City of Detroit
Inter-Departmental Communication

RE: Petition No. 1697
Requested Encroachment Into Woodward At 1247 and 1437 Woodward (With
Steel Canopies) In Bound By Clifford, Woodward, State, And Griswold

**REQUEST ENCROACHMENT
 INTO WOODWARD
 AT 1247 AND 1437 WOODWARD
 (With Steel Canopies)**

PROVISIONS FOR ENCROACHMENT For Petition 1697

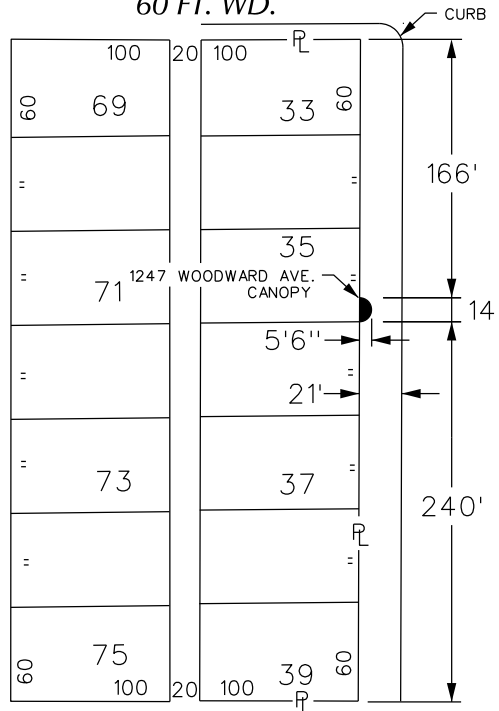
- DWSD has no objections to the requested encroachments provided that the attached Provisions for Encroachment are strictly followed.

2. DWSD requires a vertical clearance of 18 feet above grade for maintenance excess and repair.
3. All construction performed under this petition shall not be commenced until after five (5) days written notice to DWSD. Seventy-two (72) hours notice shall also be provided in accordance with P.A. 53 1974, as amended, utilizing the MISS DIG one call system.
